STAFF RECOMMENDATION
816 & 818 Shelby Avenue
July 19, 2017

Application: New construction – infill and outbuildings/detached accessory dwelling unit

District: Edgefield Historic Preservation Zoning Overlay

Applicant: Mitch Hodge, Architect

810, 812 (center, contributing), and 814 Shelby, with floor levels ranging from one foot (1') to three feet (3') above grade.

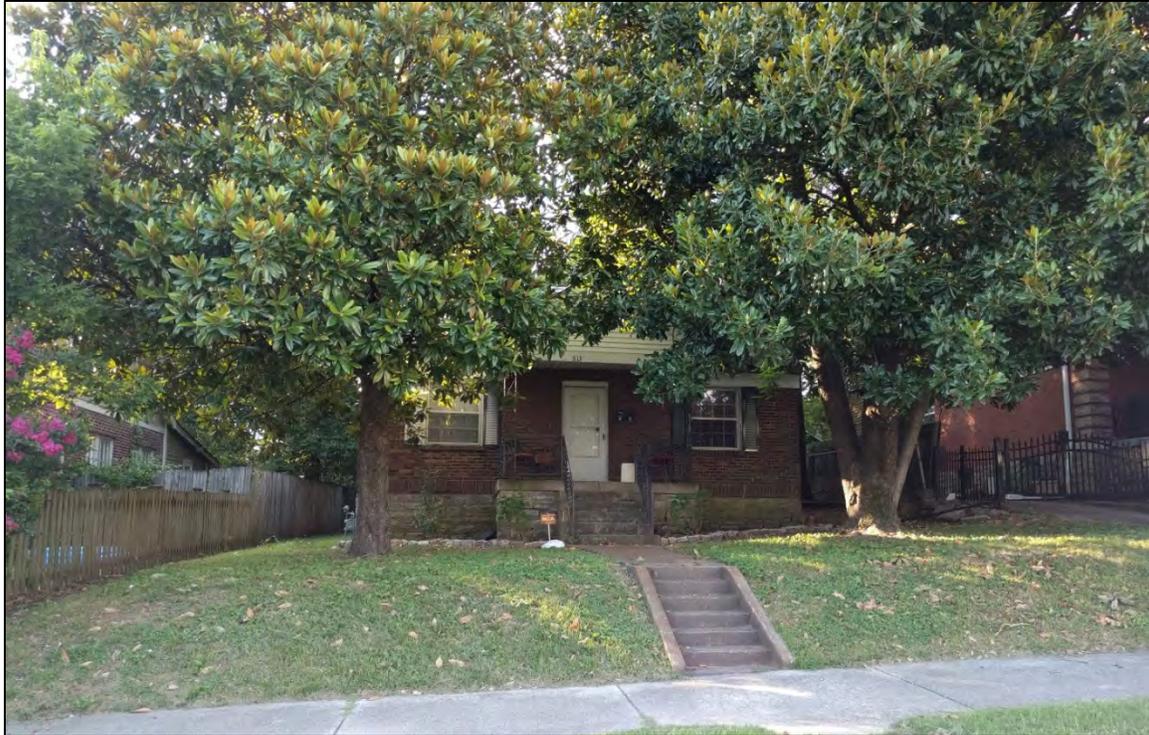
804, 802, and 800 Shelby Avenue are all contributing houses with floor heights one foot (1') above grade or less.

Houses across the street (813 Russell Street shown here) have taller foundations because the lots slope down from back to front.

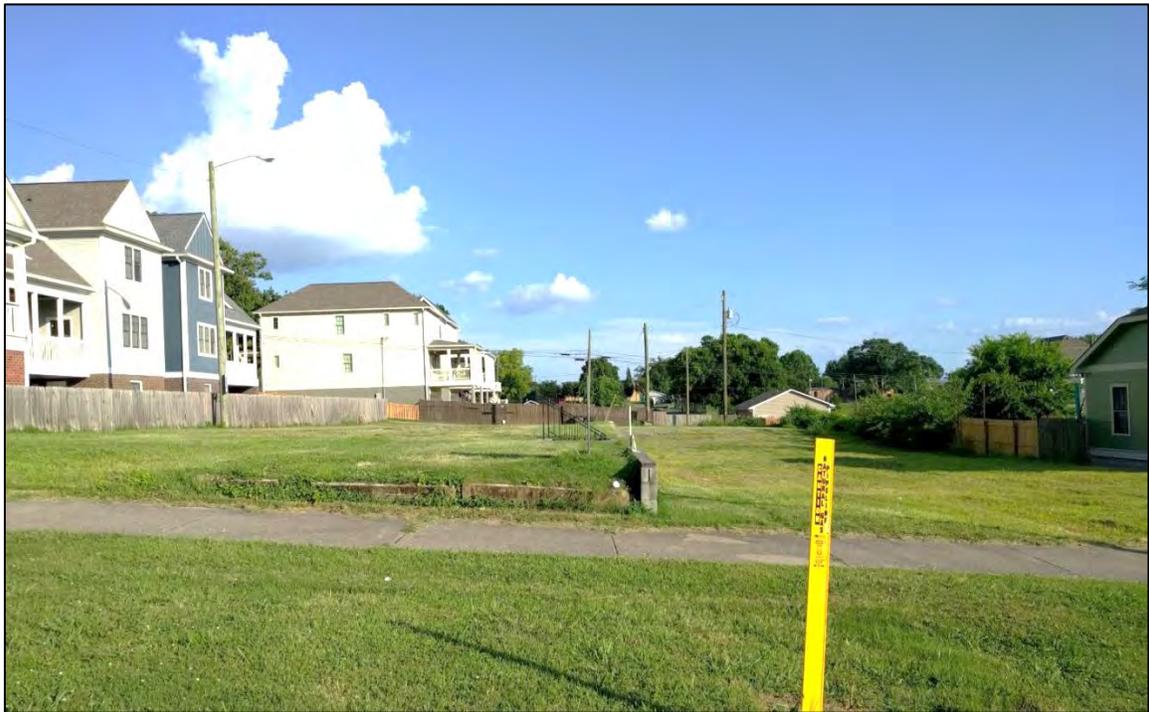
818 and 816 Shelby Avenue. Although significant slope is evident on the street and sidewalk, the lots have been flattened with grading and retaining walls for the previous one-story church building and adjacent parking lot.

A rounded bay at 816 Russell Street projects less than two feet (2') from the façade.

ELEVATIONS

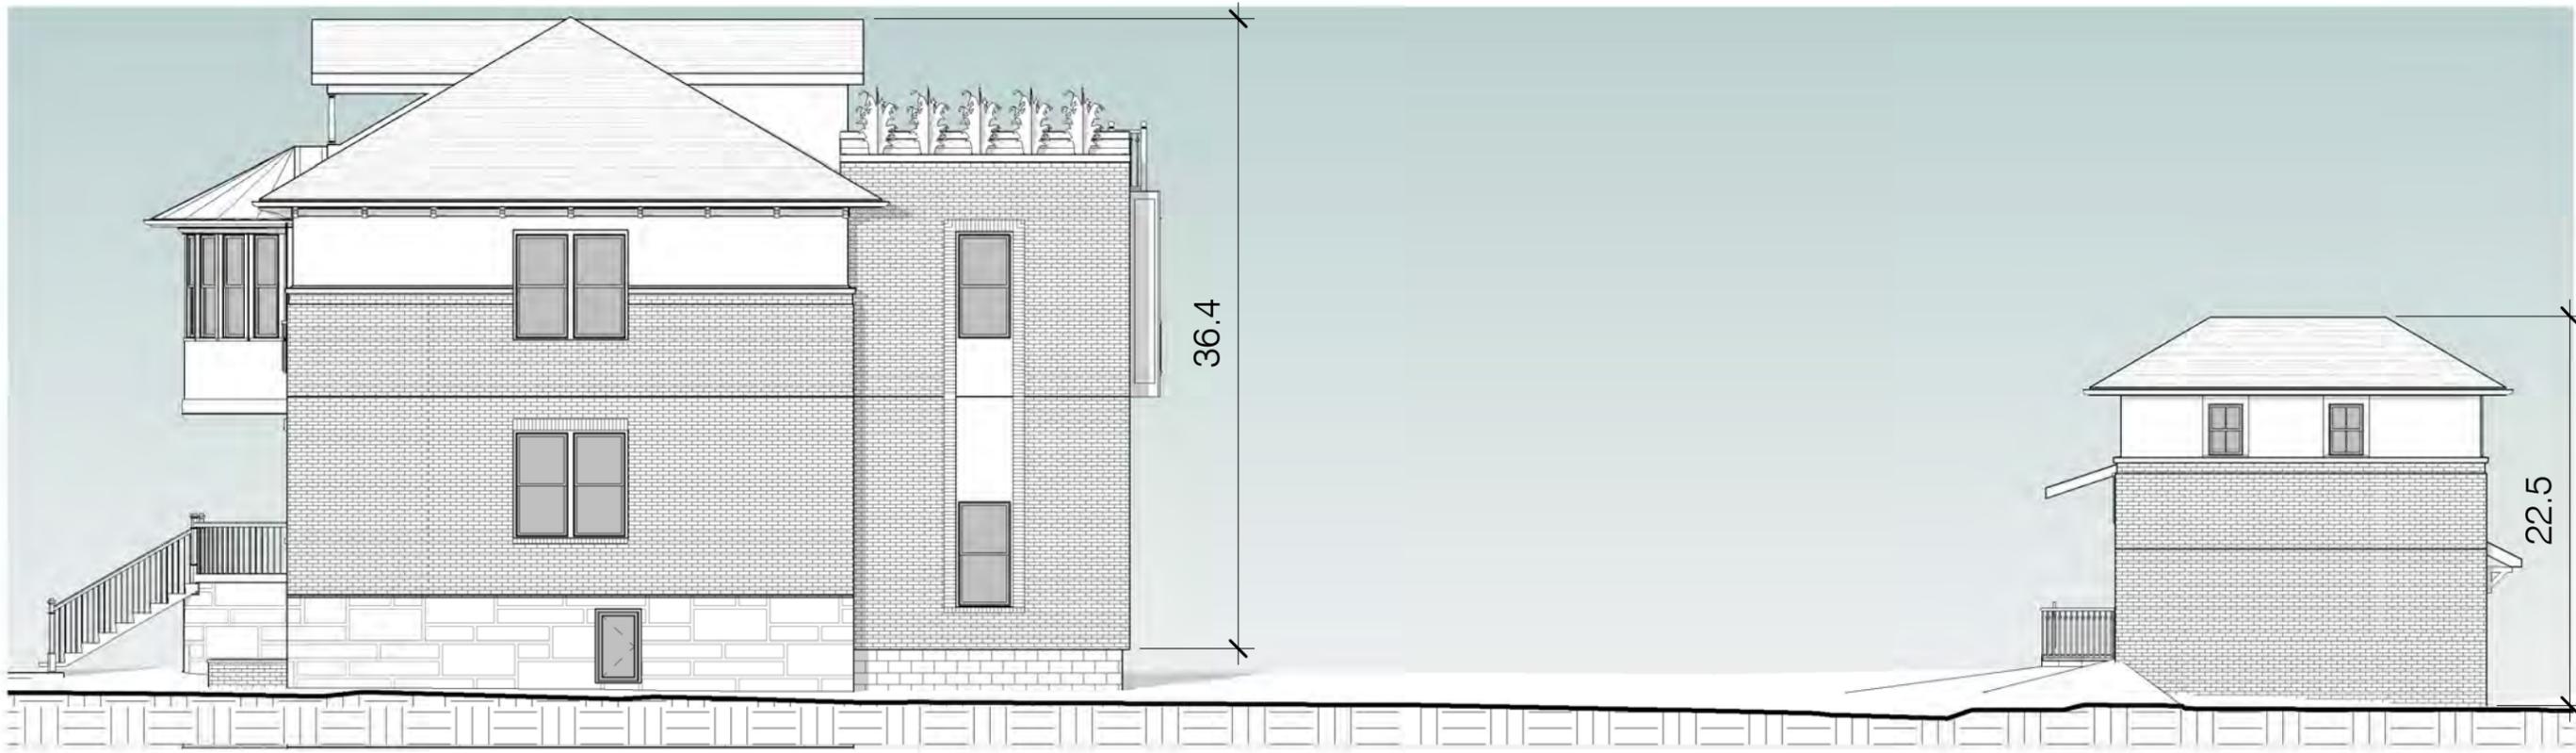
Height & Scale: The eave and roof peak heights of the two buildings will be twenty-one feet (21') and thirty-two feet (32') above the finished floor level. These proportions are similar to the eave and roof heights of comparable two-story buildings, which are typically in the range of twenty-six feet (36') to thirty-four feet (34') tall. The overall proportions of this building will be inappropriate, however, because the floor height will be significantly higher than is typical of historic houses nearby. The floor levels of the proposed new buildings will range from three feet (3') to six feet, six inches (6'-6") above grade, with eighteen inches (18") of wall material continuing down the façade and then as much as five feet (5') of exposed foundation showing.

Across the street at 813 and 815 Shelby there are historic houses with similar amounts of foundation showing, however those lots slope from the alley down to the street. Houses on this side of the street slope down from the street to the alley. Historic houses on this block face have floor levels ranging from one foot (1') to three feet (3') tall with little or no exposed foundation. Also, while the street and sidewalk slope down from left to right (East to West), the proposed building locations for both lots are fairly flat having been mitigated by grading and retaining walls previously. Because the foundation heights and floor levels are significantly higher than the surrounding context, Staff finds that the heights of the two houses will not be compatible with the surrounding historic context.

The new houses will have three bays on their front facades with porches in the center bays. Their primary mass will be thirty-seven feet (37') wide, with a semi-circular projecting bay on one side bringing the total width of each building to forty feet (40'). Historic houses in the surrounding area range from thirty feet (30') to thirty-eight feet (38') wide. Staff finds that the width of the primary width of the proposed houses would be consistent with the widths of historic houses nearby, however the width added by the projecting bays is not appropriate.

Proportion and Rhythm of Openings: The side bays of the front elevation of the building will have pairs of double hung windows on the first story with pairs of doors behind a balcony rail on the upperstory. Juliette balconies are not typical of historic houses in the surrounding area.

The projecting upperstory center bay will have a row of nine six foot (6') tall windows, each roughly eighteen inches (18') wide, angled to follow the arc of the semi-circular wall. The proportions and rhythm of spacing between openings on the front elevation are not compatible with surrounding historic houses, typified by windows roughly twice as tall as they are wide, taller on the first story than an upperstory, and having a consistent rhythm of solid walls and voids.
